LOUISIANA
POWER & LIGHT

SUBJECT: Waterford SES Unit 3
Docket No. 50-382
Response to NRC Request for Additional Information
COLSS Out-of-Service

Your Reference (1) letter requested additional information concerning a Technical Specification change request, submitted via Reference (2), dealing with monitoring plant operation when COLSS is out-of-service.

PROPOSED CHANGE NPF-38-12

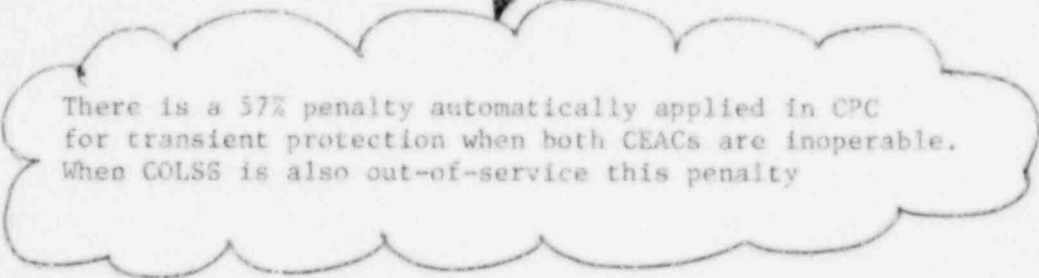
1. Question

Please comment on whether present or future cycles may contain MTC values which are not necessarily most positive at BOL. If so, the surveillance requirement should be worded so as to perform a confirmatory measurement near the cycle time of maximum positive MTC.

Response

Combustion Engineering is unaware of any case where MTC increased with core burnup for a reload core; nor are there any plans to design such a reload core in the future. Therefore, there is no need to provide additional changes to Technical Specification 3.1.1.3 beyond those proposed in NPF-38-12.
